# Access Compliance Report

## Public Rights-of-Way

### (Curb Ramps)

Intersection ID: 28521	Main Street: LIONSTONE_DR	Cross Street: GARRISON_RD	Location: W
ADA ID: 102A381573A8	Ramp Type: Perp	Initial Pass/Fail: Fail	Overall Compliance: No
Codes/Mitigation Info/Possible Solution		Field Measurements/Component Compliance	
Severity Score: 33.75

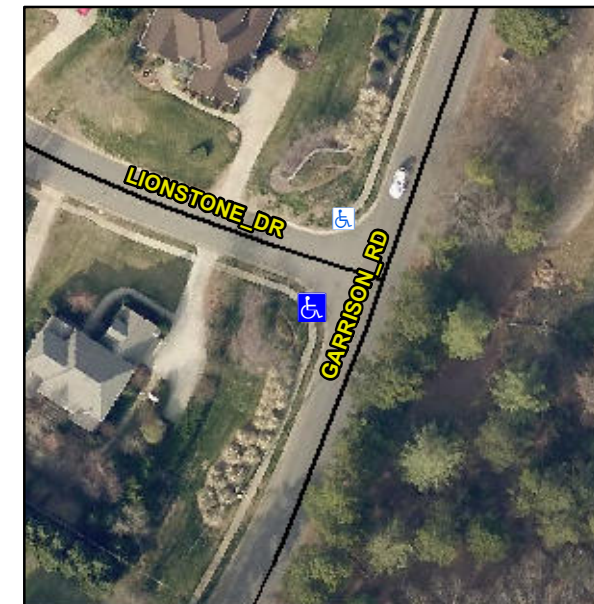
**Remove & Replace Entire Ramp.**

**Not Found, R304.5.1, R304.5.3**

Compliance	Description	Data	Compliance	Description	Data
N/A	Ramp Length (in)	44.0	Yes	Ramp Slope (%)	5.5
No	Ramp Width (in)	45.0	No	Ramp XSlope (%)	7.0
N/A	Flare Type LT	N/A	N/A	Flare Type RT	N/A
N/A	Flare Slope LT (%)	N/A	N/A	Flare Slope RT (%)	N/A
N/A	Flare Traversable LT?	N/A	N/A	Flare Traversable RT?	N/A
N/A	Landing Length (in)	N/A	N/A	DWS Provided?	N/A
N/A	Landing Width (in)	N/A	N/A	DWS Contrast?	N/A
N/A	Landing Slope (%)	N/A	N/A	DWS Length (in)	N/A
N/A	Landing X Slope (%)	N/A	N/A	DWS Full Width?	N/A
N/A	Landing Curb? (Y/N)	N/A	N/A	DWS Offset (in)	N/A
N/A	Shared Landing?	N/A			
N/A	Gutter Ponding?	N/A	N/A	Gutter Slope (%)	N/A
N/A	Gutter Lip Ht (in)	N/A	N/A	Gutter X Slope (%)	N/A
N/A	Painted X Walk1?	No	N/A	Painted X Walk2?	N/A
	X Walk 1 Direction	To NE		X Walk 2 Direction	N/A
N/A	X Walk 1 Width (in)	N/A	N/A	X Walk 2 Width (in)	N/A
	X Walk 1 Slope (%)	0.5		X Walk 2 Slope (%)	N/A
	X Walk 1 X Slope (%)	8.2		X Walk 2 X Slope (%)	N/A
